Fabrication Engineering at the Micro and Nano Scale
Third edition of "The Science and Engineering of Microelectronic Fabrication",
Oxford University Press, 2008
Stephen A. Campbell
Errata file
Last updated 9/16/11
Many thanks to all who have contributed to this list

Chapter 13
Page 363 – Example 13.2.

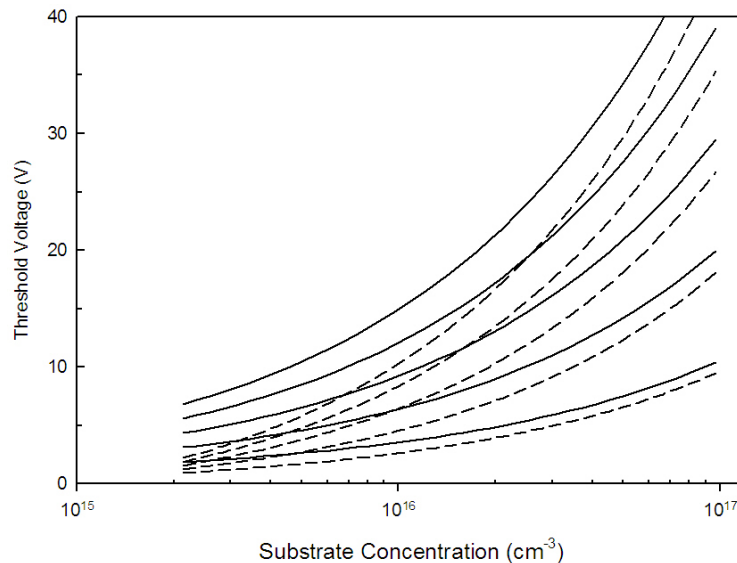
The first equation should be
z_v = a/25 * U * rho/mu = a^2/25 * U * rho/eta
Page 380 – 2nd paragraph, aluminum was misspelled as aliminnum
